DEVELOPMENT APPLICATION ASSESSMENT REPORT

Application Number:	DA2025/0354
----------------------------	-------------

Responsible Officer:	Kye Miles
Land to be developed (Address):	Lot 38 DP 33000, 70 Hilma Street COLLAROY PLATEAU NSW 2097
Proposed Development:	Demolition works and construction of a dwelling house
Zoning:	Warringah LEP2011 - Land zoned R2 Low Density Residential
Development Permissible:	Yes
Existing Use Rights:	No
Consent Authority:	Northern Beaches Council
Land and Environment Court Action:	No
Applicant:	Helen Tracy Dixon

Figure 1. Extent of southern side boundary envelope non-compliance.

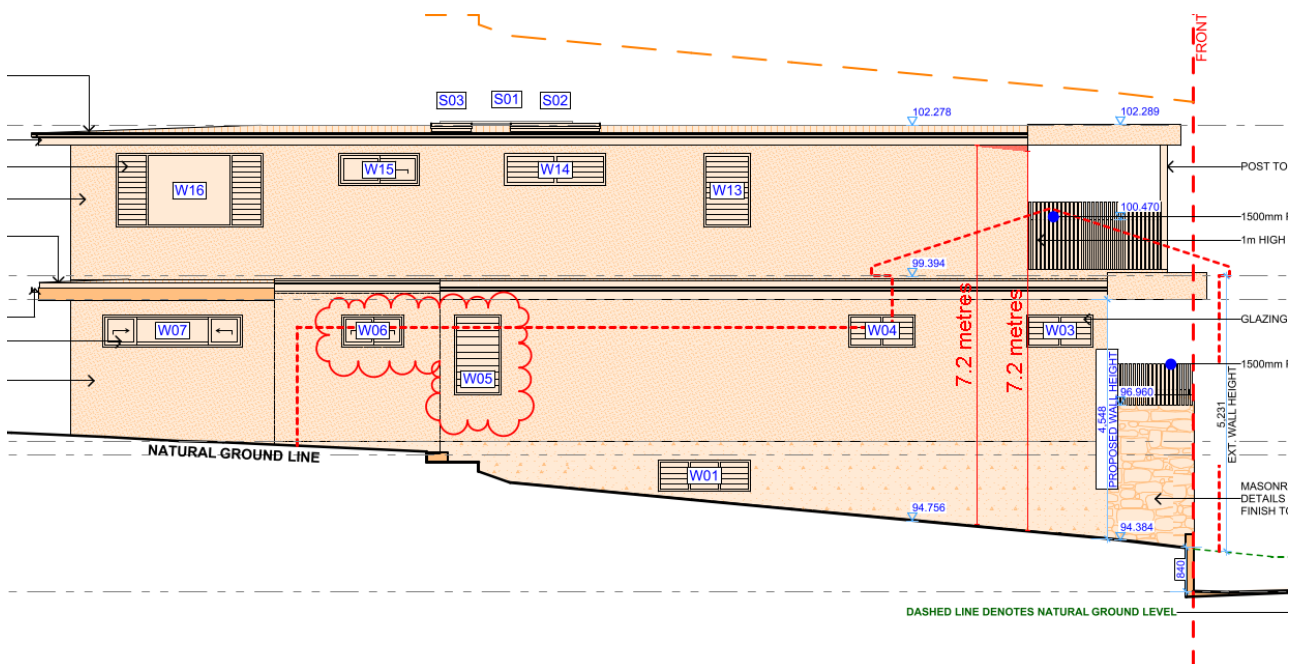
WDCP requires buildings to be sited within a building envelope determined by projecting planes at 45 degrees from 5.0 metres above ground level (existing) at the side boundaries. The proposal encroaches the prescribed envelope on the southern boundary up to 0.1 metres for a length of 1.0 metres.

The minor envelope encroachment will not give rise to adverse amenity impacts.
